From: Scala, Mary Joy
Sent: Wednesday, May 27, 2015 10:24 AM
To: 'stinson.scott@gmail.com'
Subject: BAR Actions - May 19, 2015 - 211 W Main Street

Certificate of Appropriateness Application

BAR 15-05-02
211 West Main Street
Tax Parcel 330268000
211 West Main LLC, Owner/ Scott Stinson, Applicant
Alterations to 2nd and 3rd floors; remove rear stairs

**CITY OF CHARLOTTESVILLE
BOARD OF ARCHITECTURAL REVIEW
STAFF REPORT
May 19, 2015**

Front Elevation

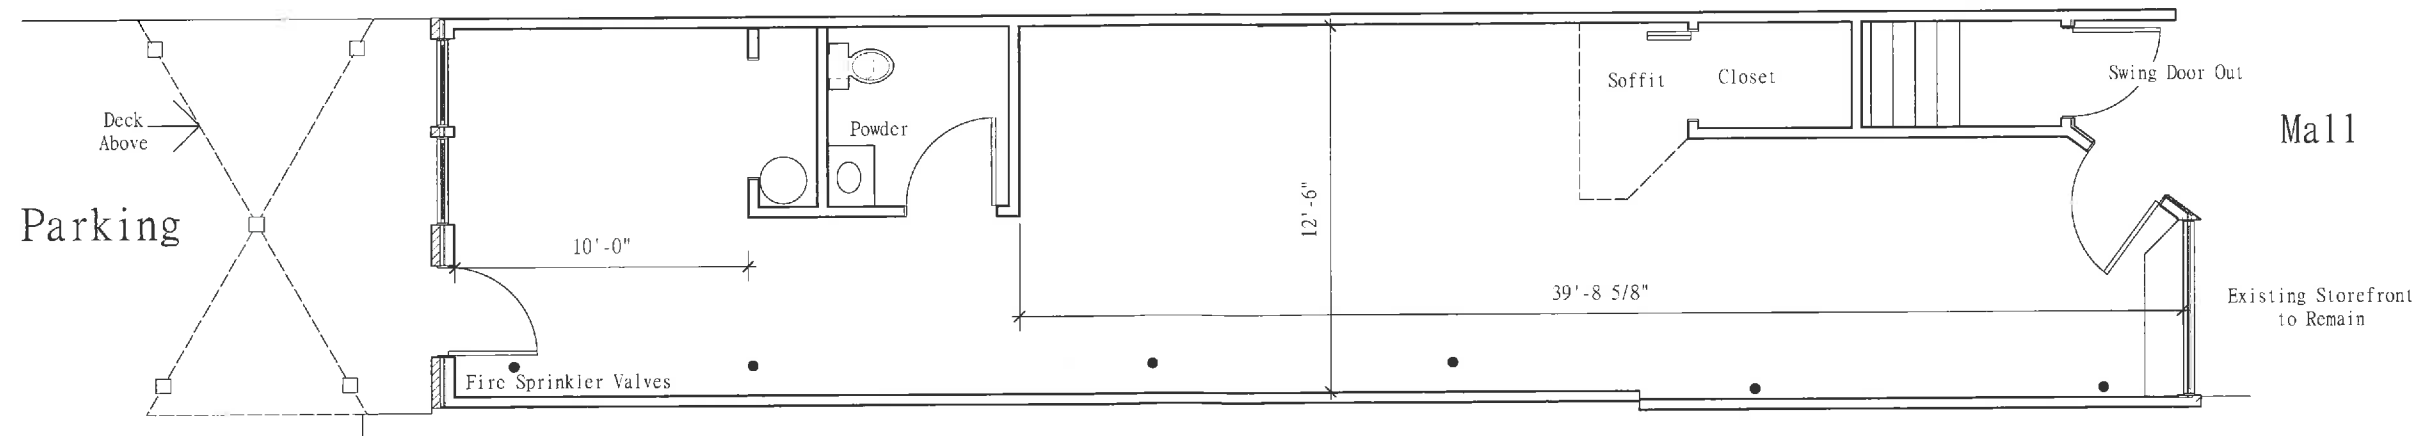
In this case, the existing windows date from 1988. The proposed wood windows and sliding doors are appropriate. The front double hung windows should match existing.

The BAR approved (9-0) the application as submitted, with pressure treated rear railing stained gray (of a more inventive design should the applicant please) and if determined that the two windows on the 2nd floor main façade need to be replaced, the applicant shall contact staff for approval of the type of window.

Rear Elevation

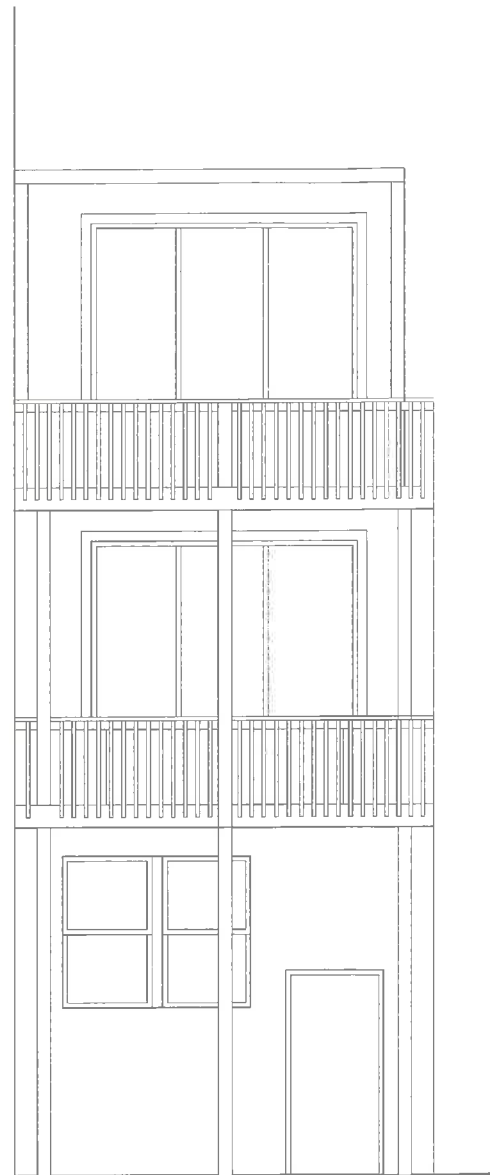
Because all the railings in the alley are currently pressure-treated lumber, it would be appropriate to replace the stairs with pressure-treated decking and railings. White vinyl railings are not appropriate.
